OKLAHOMA STATE CAPITOL RESTORATION  
*Exterior Rehabilitation*

15039DB MONTHLY CONSTRUCTION PROGRESS REPORT

Project: Oklahoma Capitol Restoration – Exterior Rehabilitation  
CAP PROJECT 15039DB

Reference: 040343 – Joint raking and initial repointing

#### Raking & Repointing of Limestone Mock-Up Example

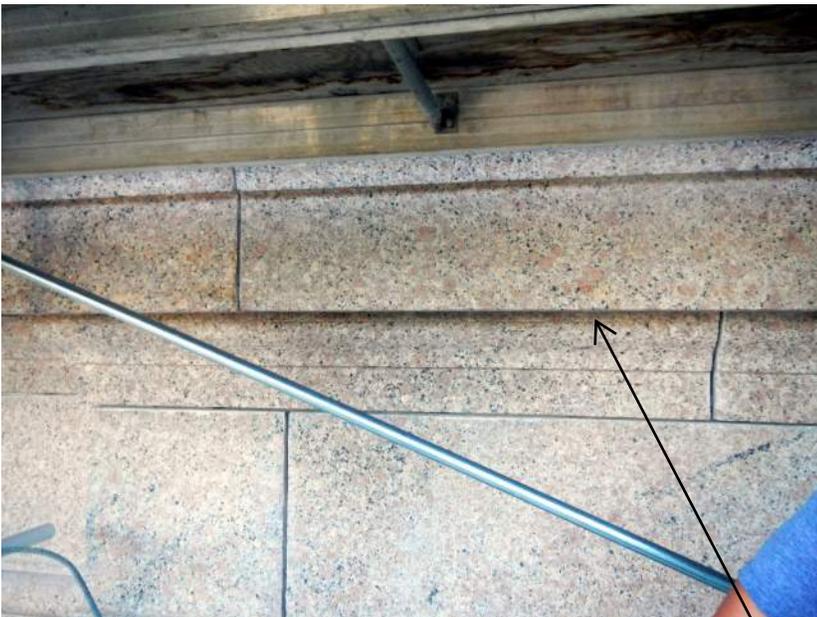
Mock Ups Reviewed: Reviewed joint raking at granite and limestone. Mock up performed on A206 at the north end of the façade. Initial repoint included filling open joints at the granite water table with setting mortar and with grout.

Some pointing mortar was applied in the limestone area to facilitate discussions about options for finishing with the striping remaining in place; two finishes were installed 1) flush and 2) concave. Granite is to be similarly pointed prior to review for color and finish in follow up visit.

Reviewed weather limitations and curing processes. Areas will be reviewed to look for bond line failure on future site visits – this was an issue with the trial repairs, particularly in the granite the previous year.

- 
1. Verify depth of raking.
  2. Verify depth of backer rod when using detail A2/A403 and A3/A403.
  3. Verify depth of initial repointing to allow ½" final pointing, minimum. Rake out excess mortar prior to setting.
  4. Verify mortar removal from entire height of joint under the granite water table and other joints that are difficult to access due to geometry.

Partial view of raked area granite area

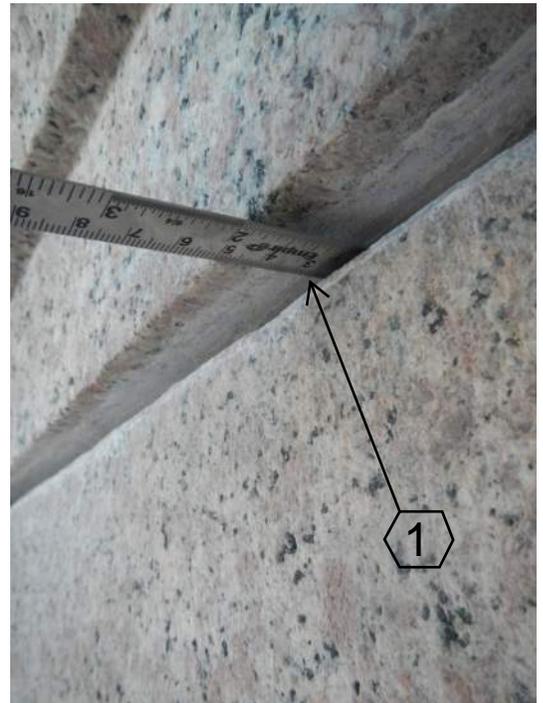
Verify raking has reached 1" minimum depth specified

Bed joint under the water table is challenging to reach due to geometry of overhanging stone - verify previous mortar has been removed entirely. Small area was not complete upon review

— small void found in bed joint

Photo 1 - 18 inch Channel Framing Across Window 264

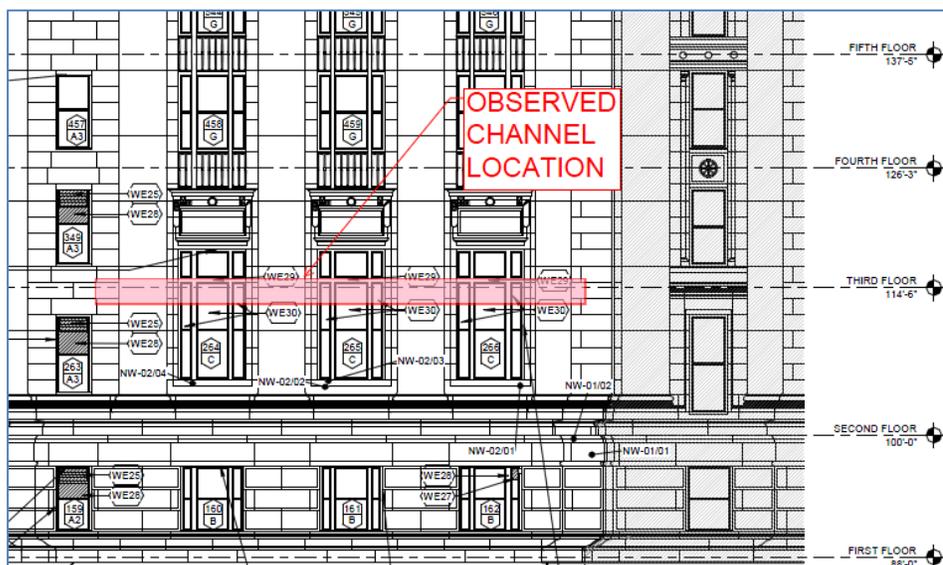
1. After removing the temporary opening covers, ZFI personnel observed an 18 inch steel channel framing across the top portion of the window opening (See Photo 1 below).

6. Based on conversations with Heath Glenn, this channel was preventing the removal of the narrow, lower sidelights on each side of the aforementioned windows. The sidelight removal appeared to be contingent on removing a stay at the top of the window, tilting the sidelight frame into the interior, and then lifting it out of the larger window frame. The full 18 inch depth of the channel impaired the removal of the stay and prevents the tilting and lifting of the sidelight out of the frame (Photo 8).

7. After observing the framing and discussing the window conflict with Mr. Glenn, it was proposed that alternative window frame removal options be considered in lieu of attempting to modify the undocumented framing. It is our understanding that JE Dunn has begun to explore those options with the window designer and restoration subcontractor.
